WLJ9 - Tightening Screws on Rear Spoiler Blade (Workshop Campaign)

Model Line: **Taycan (Y1A)**

Model Year: **As of 2020 up to 2021**

Subject: **Rear spoiler blade**

Installation position of screws for rear spoiler blade

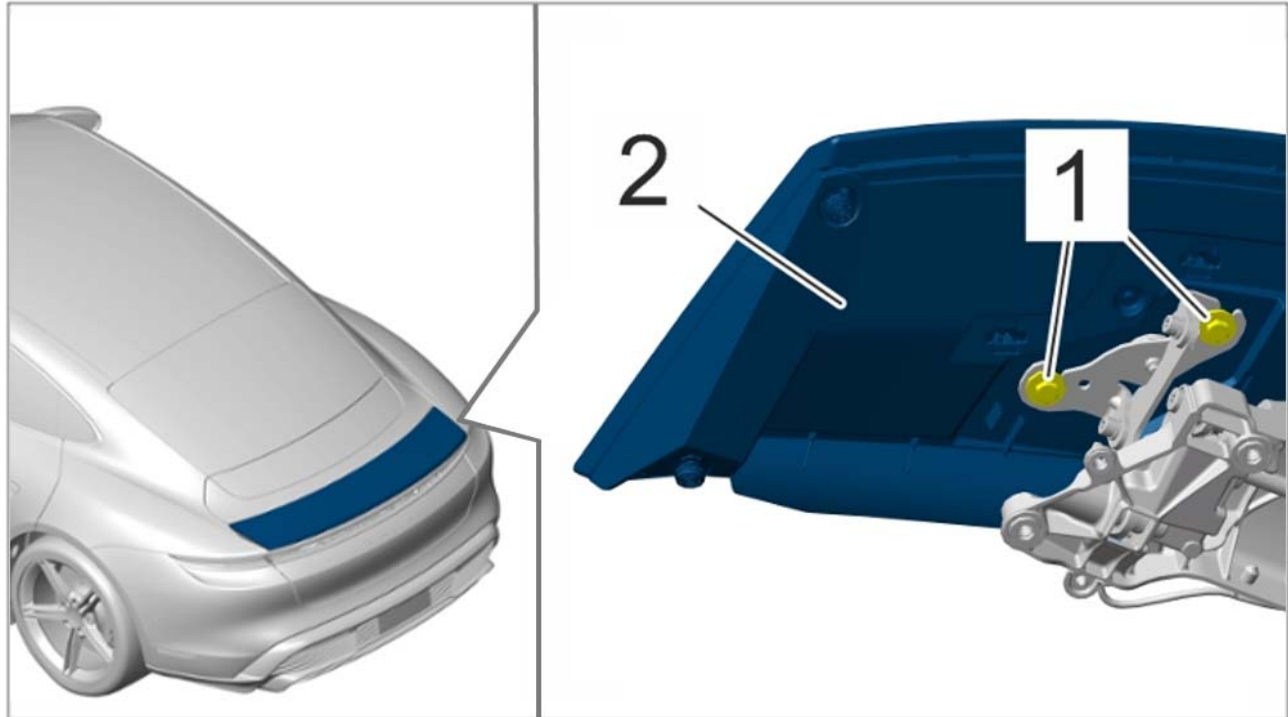
Information: **There is a possibility that a fastening screw on the rear spoiler blade threaded connection was not screwed to the drive unit for the rear spoiler using the prescribed tightening torque on the affected vehicles.**

As a result, the possibility that this fastening screw will loosen over the service life of the vehicle cannot be ruled out.

- 1 – Screws on rear spoiler blade (**tighten**)
- 2 – Rear spoiler blade

Remedial Action: Tighten screws on the rear spoiler blade to the prescribed tightening torque.

Screws on rear spoiler blade

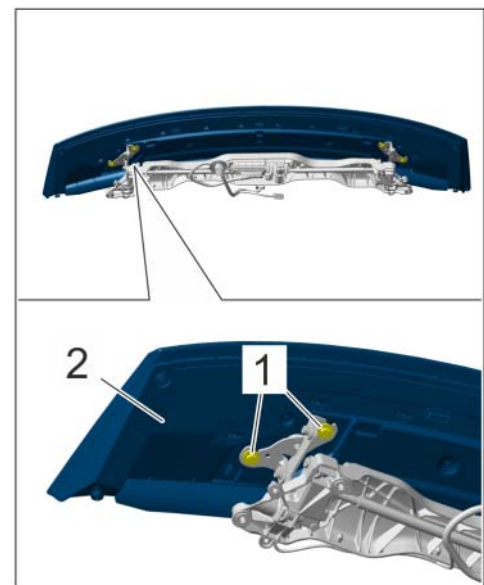
- Tighten screws on rear spoiler blade.
To do this, tighten the four fastening screws ⇒ *Screws on rear spoiler blade -1-* to the prescribed tightening torque.

Tightening torque 8 Nm (6 ftlb.)
